ACCESSION NBR: 8402090241 DOC. DATE: 84/02/07 NOTARIZED: NO DOCKET #
 FACIL: 50-275 Diablo Canyon Nuclear Power Plant, Unit 1, Pacific Ga 05000275
 AUTH. NAME: SCHUYLER, J.O. AUTHOR AFFILIATION: Pacific Gas & Electric Co.
 RECIP. NAME: EISENHUT, D.G. RECIPIENT AFFILIATION: Division of Licensing

SUBJECT: Forwards response to NRC questions concerning allegations listed in SSER 2t re design of small bore piping. Questions discussed w/NRC on 840119 & 31.

The Staff questions and PGandE's responses are documented in the enclosure.

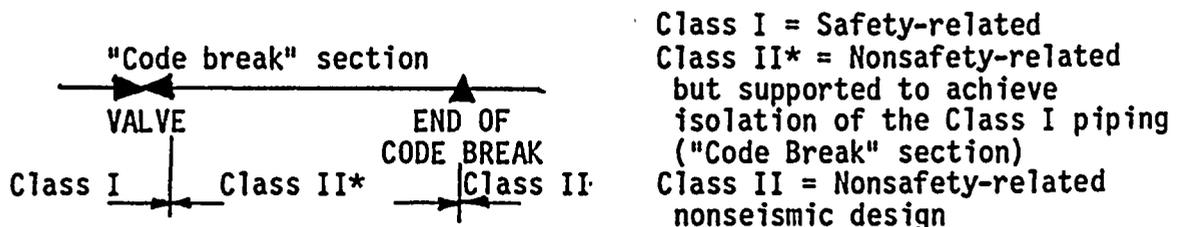
NRC Question: The NRC has raised a question about Code Break designations (Allegations 55, 86, and 88, SSER 21). This matter was further addressed by Dr. Hartzman at the public meeting on January 31, 1984.

The term "code break" is used to describe the section of a piping system where the safety-related piping (Class I) changes to nonsafety-related (Class II) piping (see the figure below). This "code break" section is always located on the Class II piping and starts at the valve which is the point at which the fluid system class changes from Class I to Class II. Within the "code break" section is a system of supports or an anchor that dynamically isolates the Class I piping from the remainder of the Class II piping. The "code break" section of the pipe ends when dynamic isolation has been accomplished. The criteria used to achieve the desired isolation, as discussed in the Phase I Final Report, require that the system of supports that provides dynamic isolation be made up of either: (1) an anchor or (2) at least two lateral supports in each direction and one axial support. The anchor, or supports, are denoted as Class II* supports and are designed to the same criteria that are used for Class I supports.

In the above schematic, the length of Class II* piping is not important as long as the code break requirements are met by providing supports or an anchor. If the length of the Class II* section of piping can be shortened by relocating the Class II boundary closer to the Class I boundary, the system would then require fewer Class II* supports; this relocation is only accomplished by adding supports or an anchor to the code break section closer to the Class I boundary. As an example, assume that following the valve, the code break section included five bilateral supports (these provide support in both lateral directions at one location) and then an axial support. All these supports would require Class I qualification. Two alternatives for improvement of the design that are acceptable and meet all licensing criteria are: (1) to add an anchor at the location of the first bilateral support, or (2) to add an axial support at the location of the second bilateral support. Both alternatives reduce the length of the code break and the number of supports requiring Class I qualification.
